BOARD OF ARCHITECTURAL REVIEW PUBLIC HEARING

CITY HALL, MARKET SQUARE GARAGE AND PLAZA RENOVATION

05 NOVEMBER, 2025

MARKET SQUARE PLAZA : SHADE STRUCTURE & STAGE CANOPY

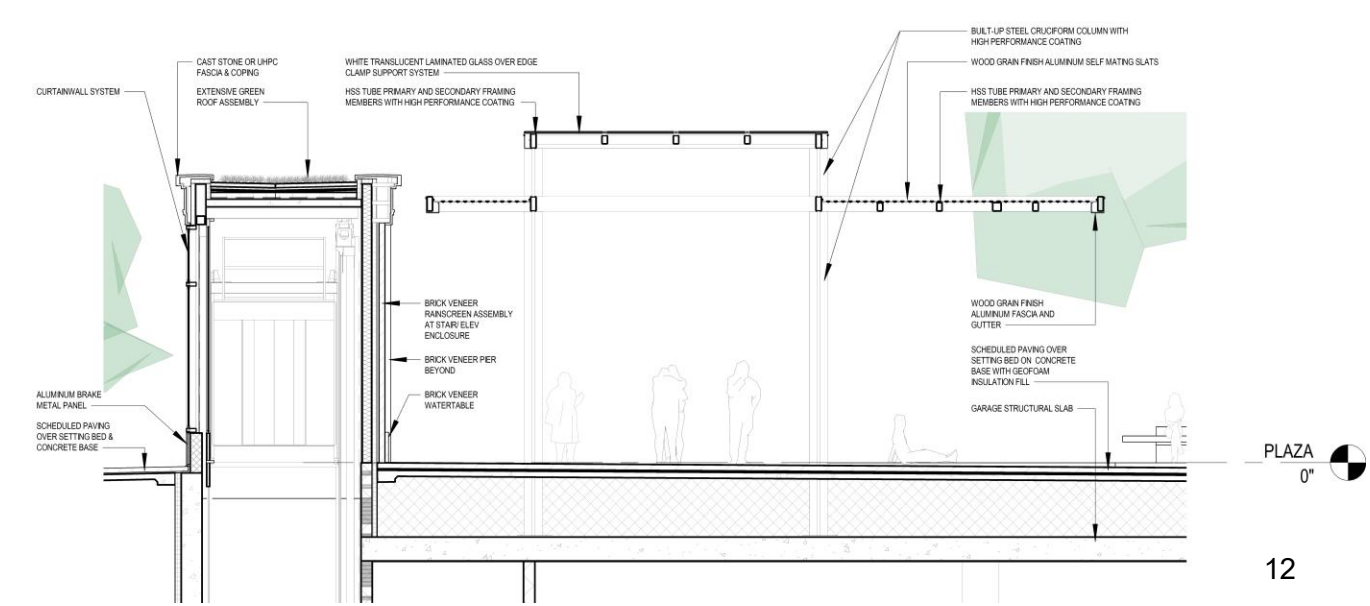
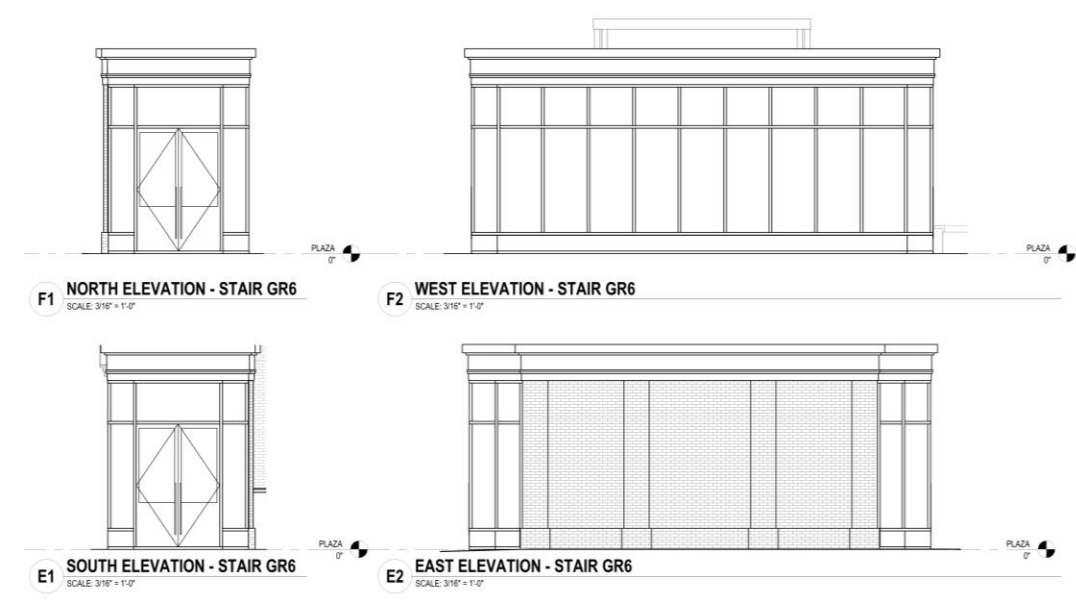
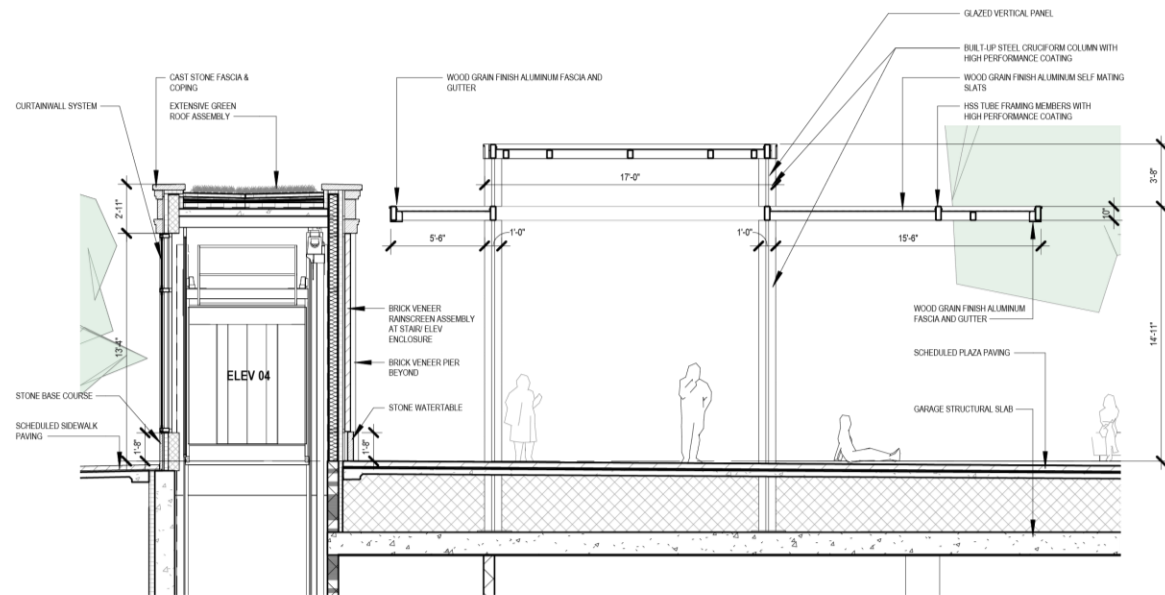
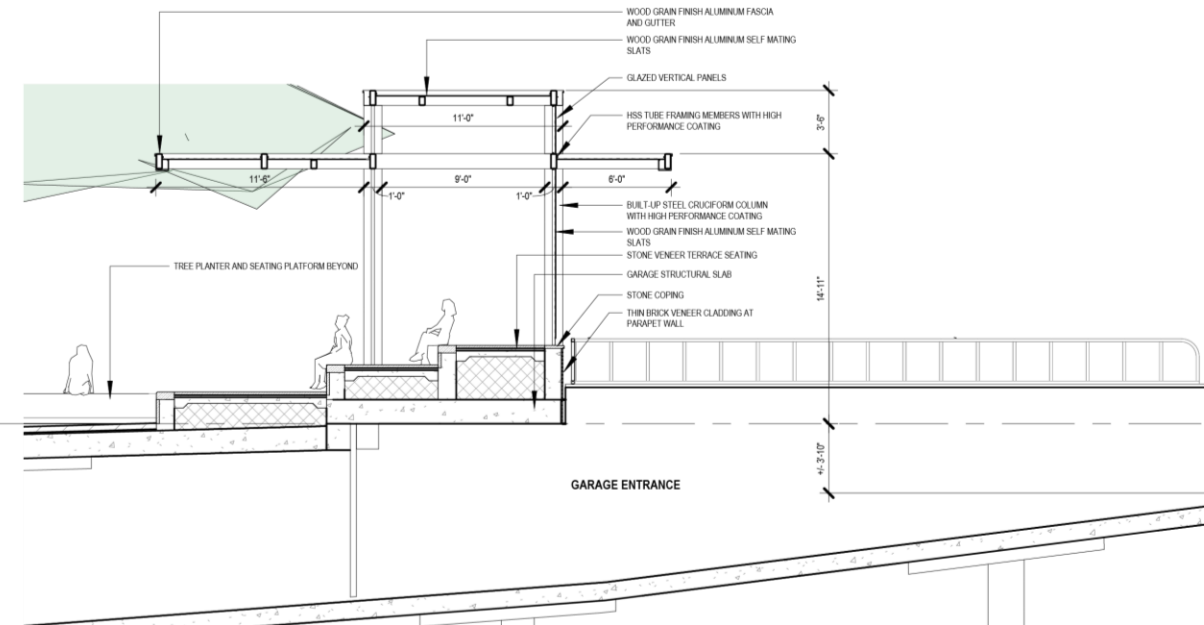
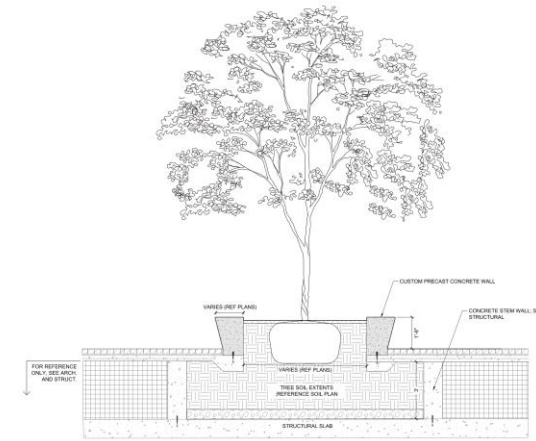
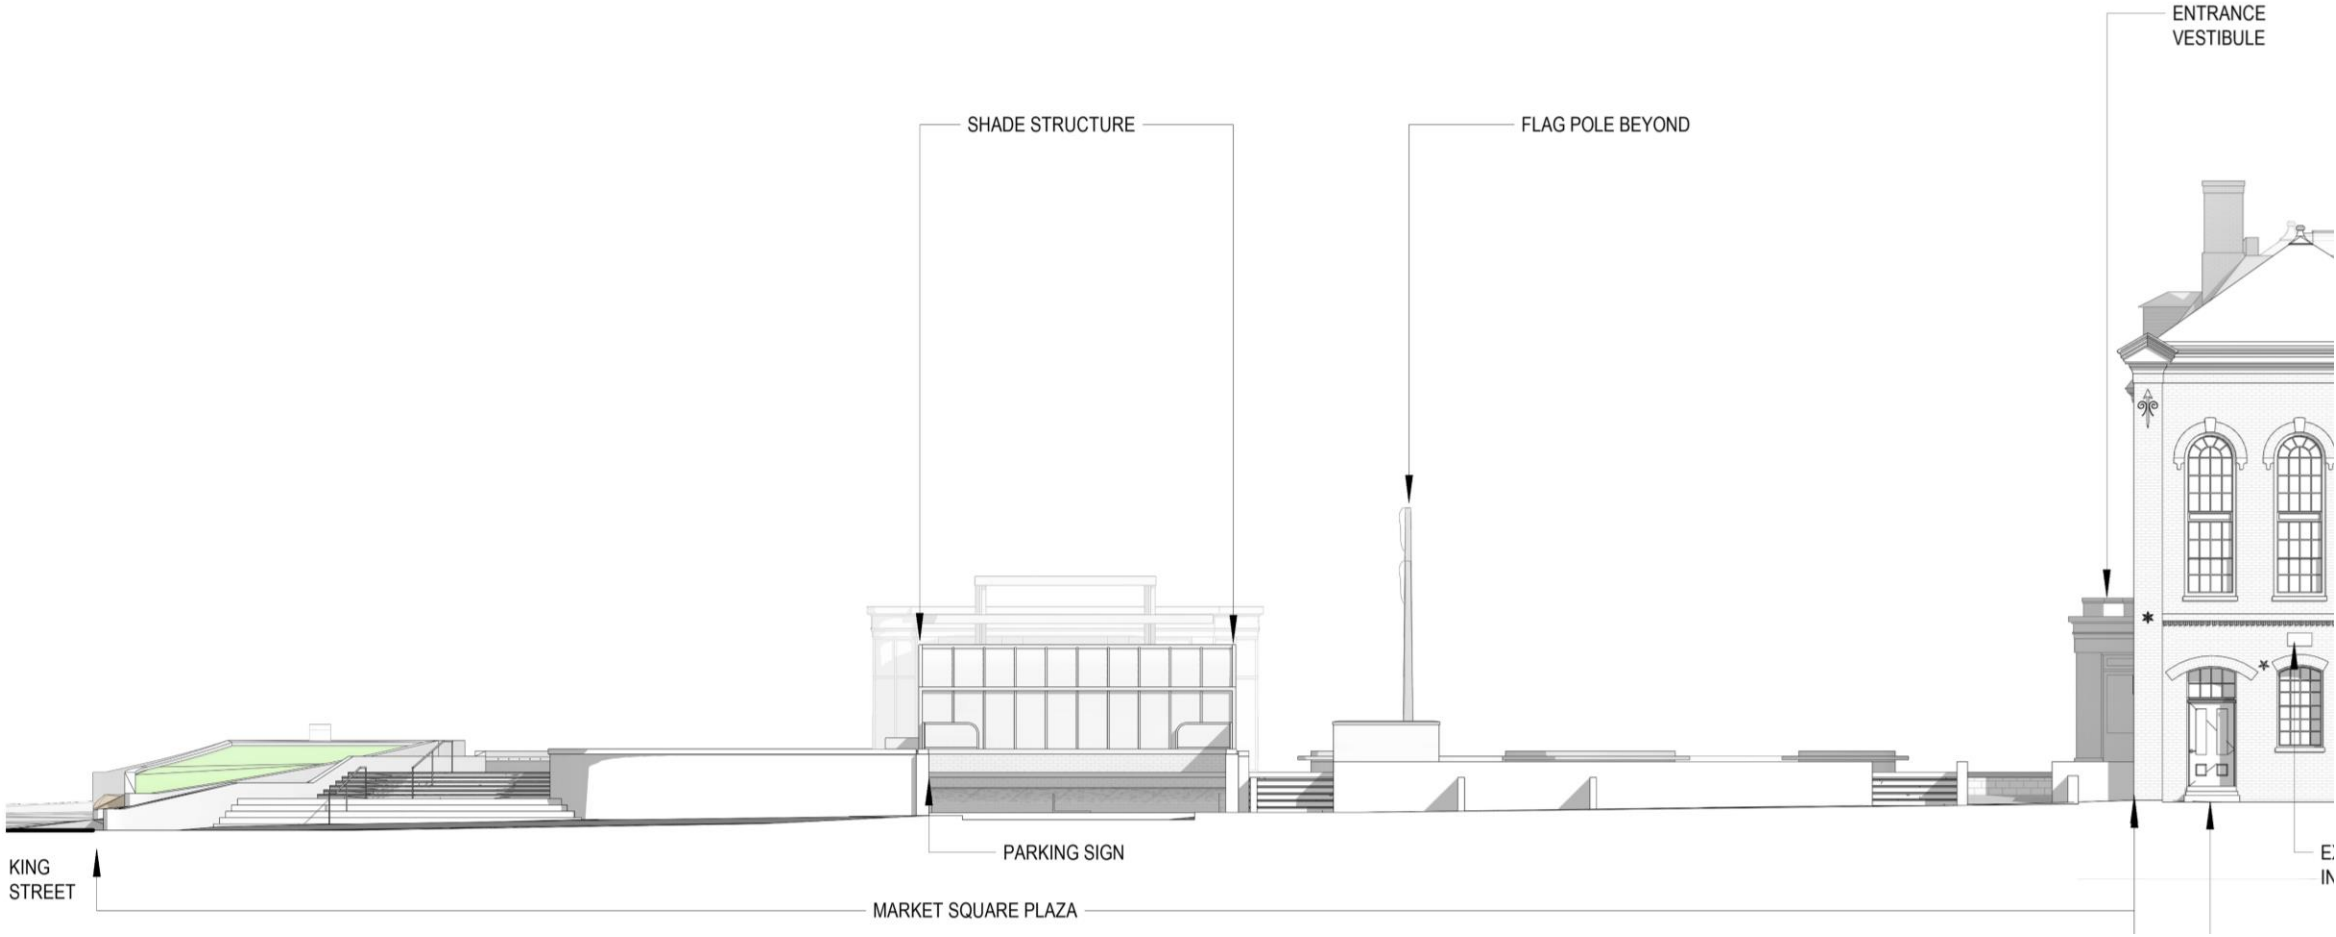
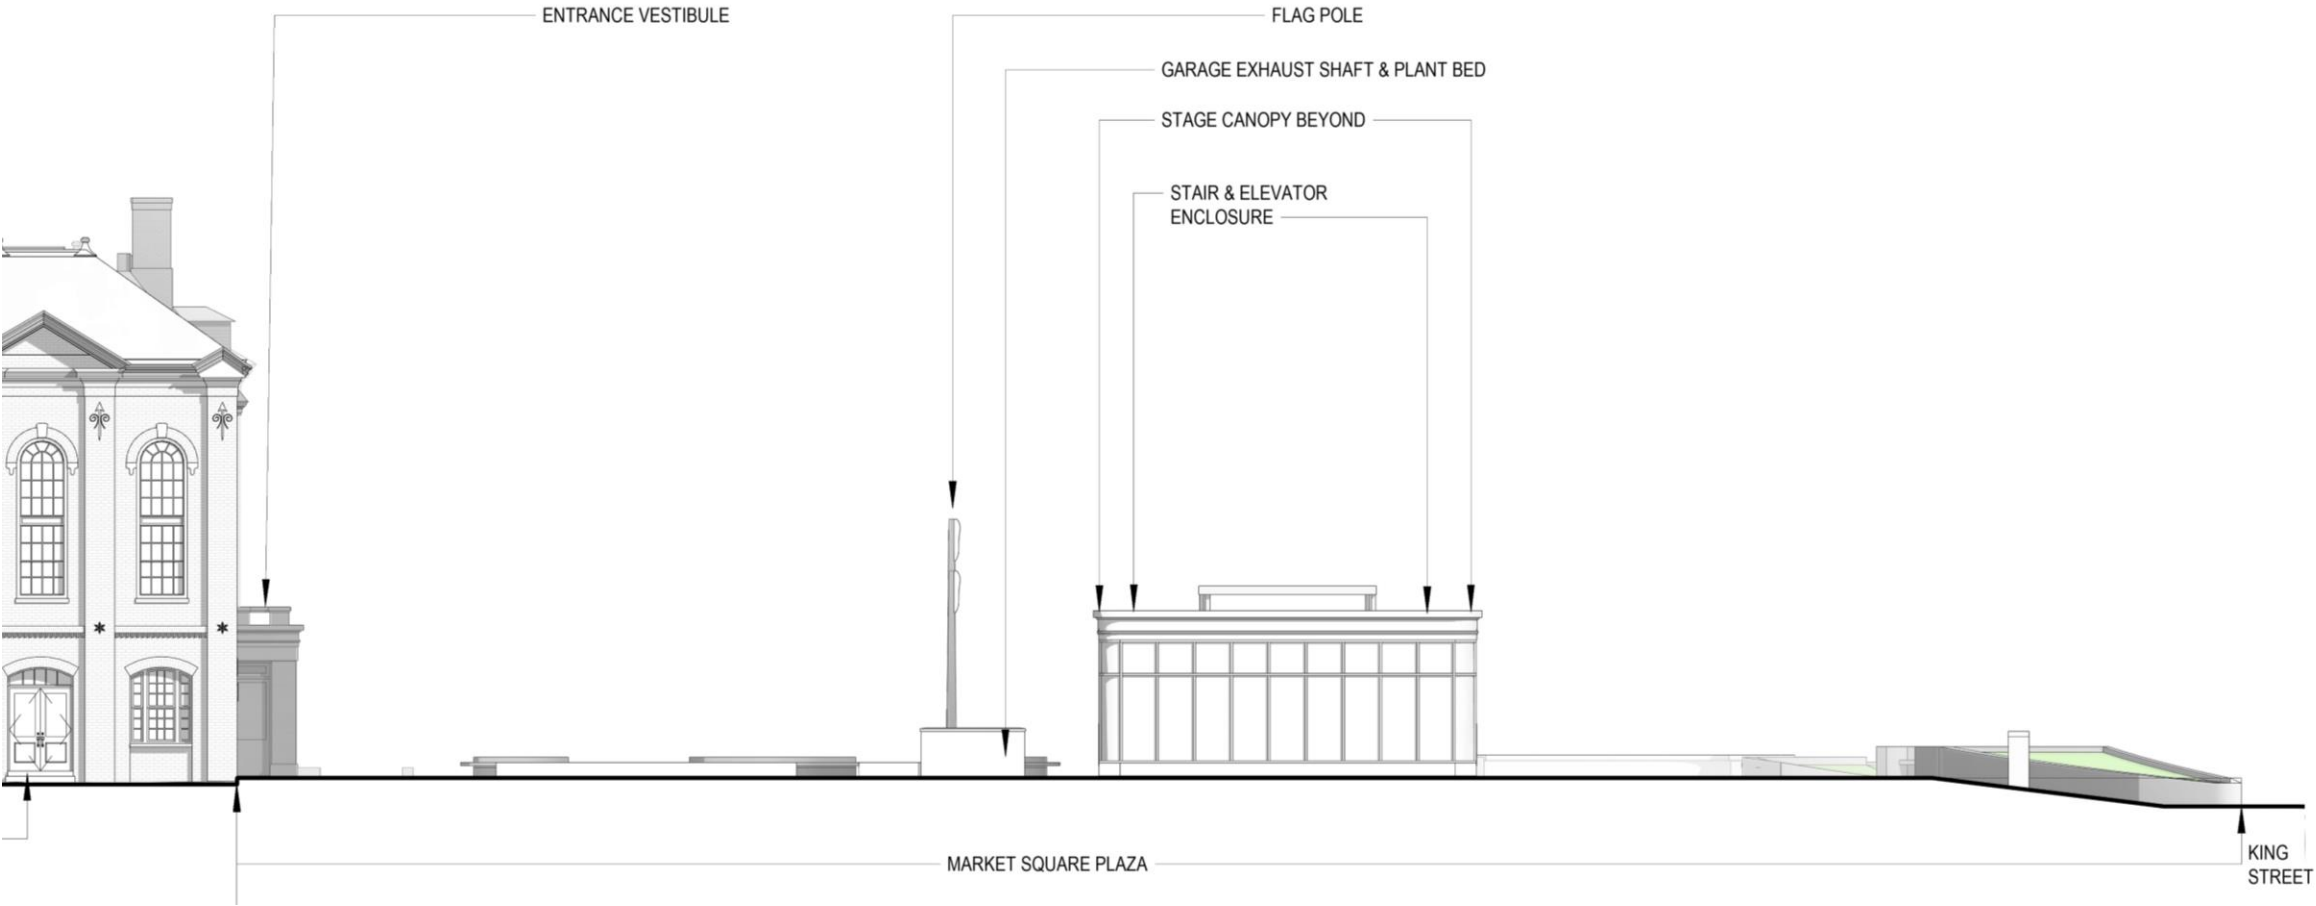
- I. **Seat walls** revised with rectilinear corners (with eased edges for durability), but ergonomics of sloped profile are desired - ACCEPTED
- II. **Stone base** in lieu of metal at elevator building - ACCEPTED
- III. **Canopy** at east revised to mimic west with integrated railing around ramp opening - ACCEPTED
- IV. **Elevated pop-ups at canopies** should have glazing panels to protect from all elements - ACCEPTED

FIFTH FLOOR PROPOSED PLAN: SETBACKS FROM LOWER ROOF

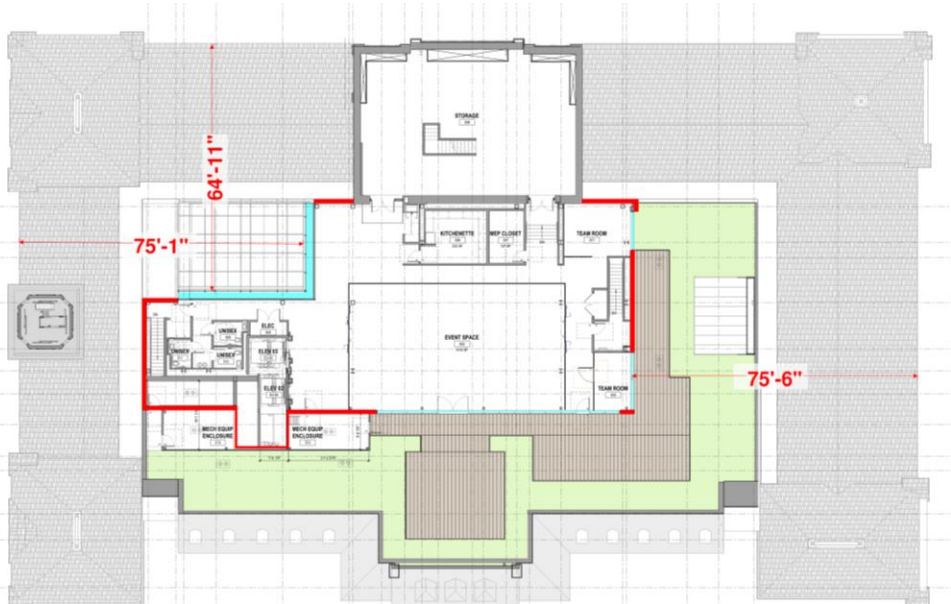
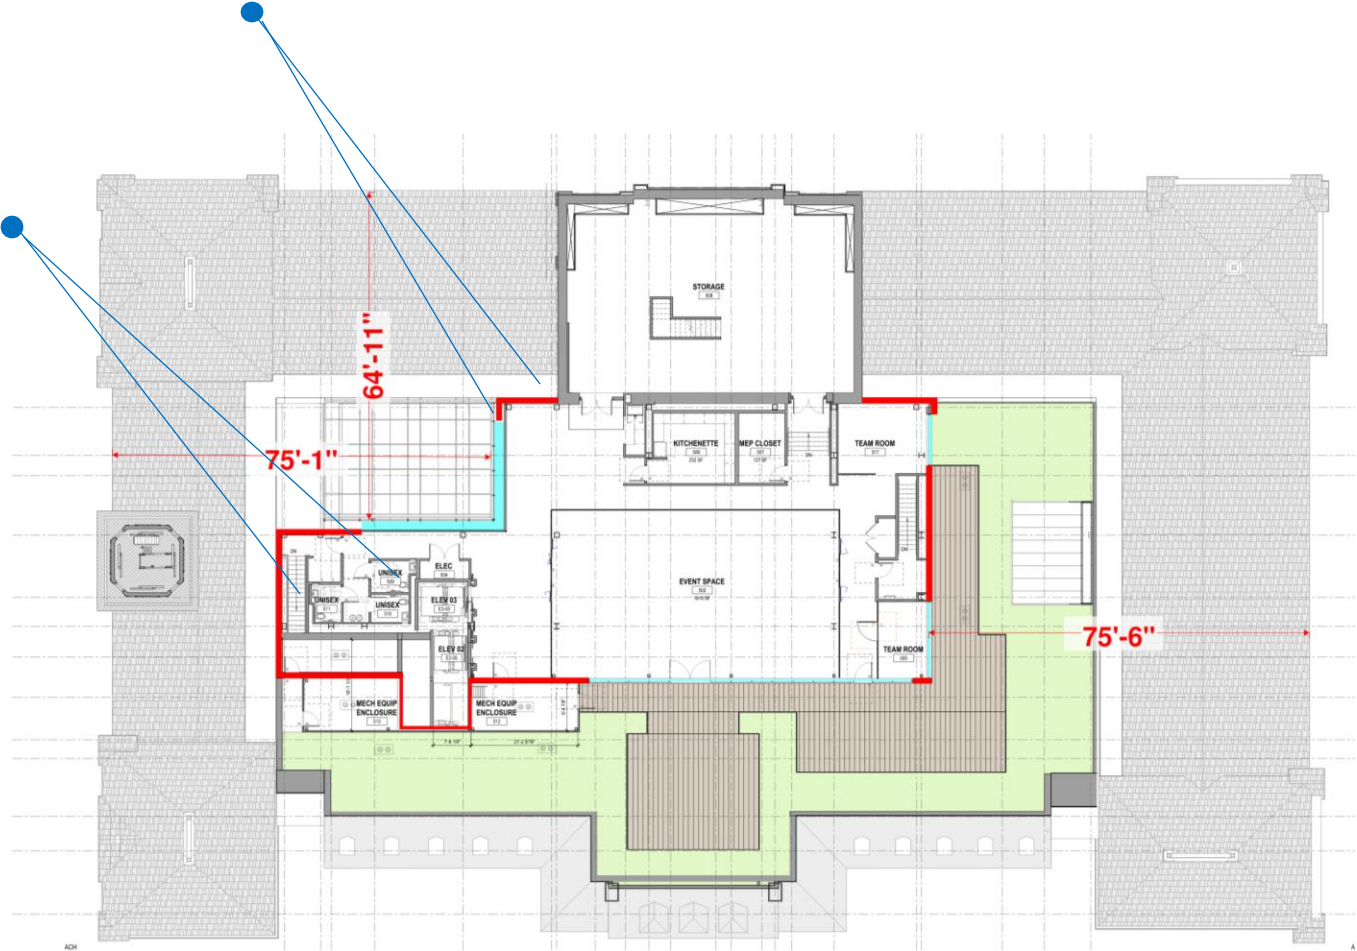
- I. No glazing should be visible from Cameron and Royal Streets - **ACCEPTED**

COMPOSITIONAL HYPHENS (STAIRS)

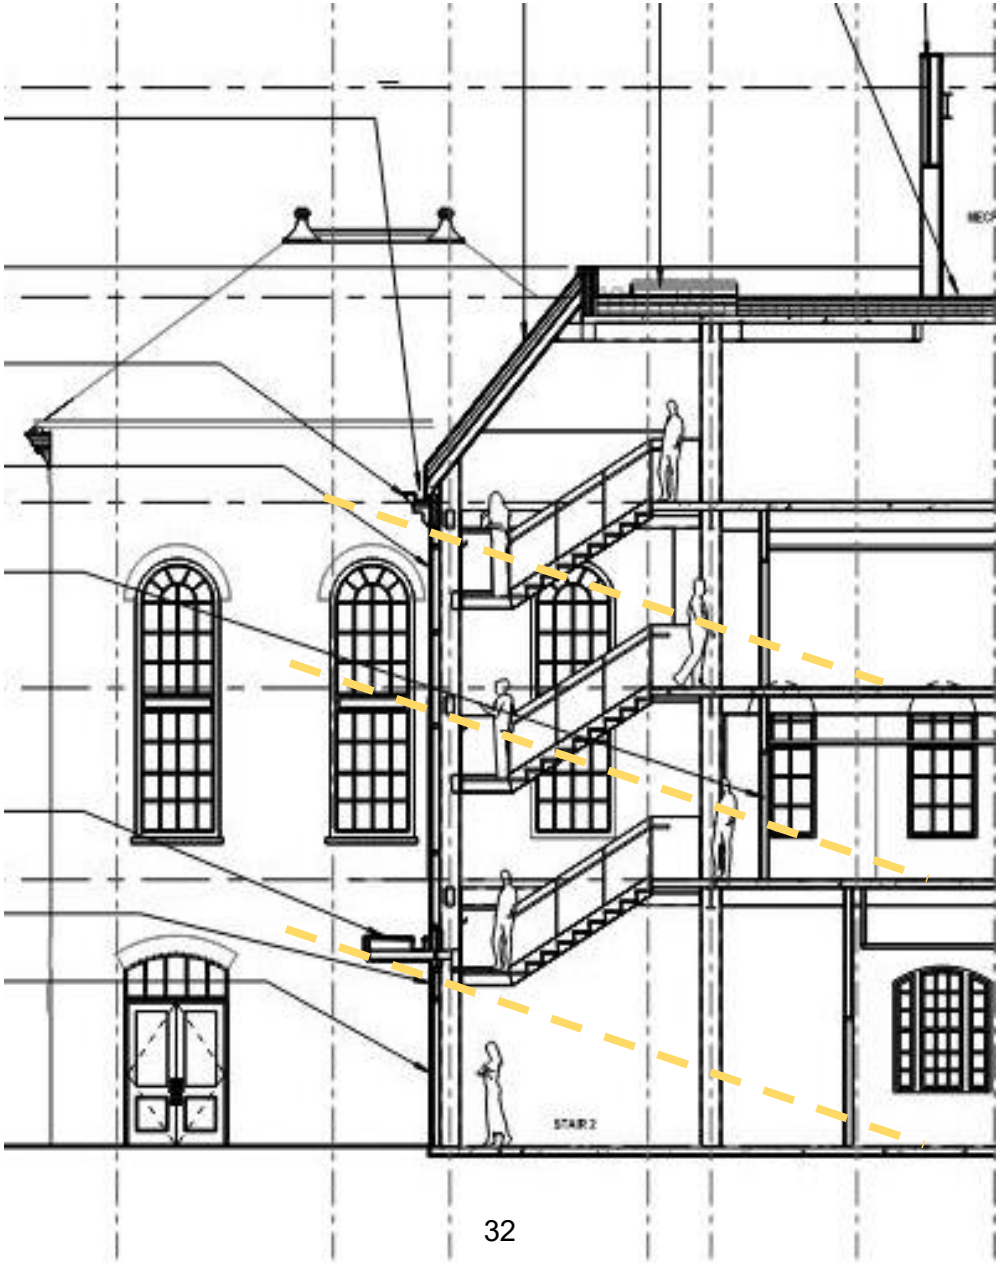
- I. All glass with fewer mullions - **ACCEPTED**
- II. Raise canopy to jack arch height, align width with doors, leave sides open to above - **ACCEPTED**
- III. Solid dark bronze doors - **ACCEPTED**
- IV. Hipped roof – **ACCEPTED**
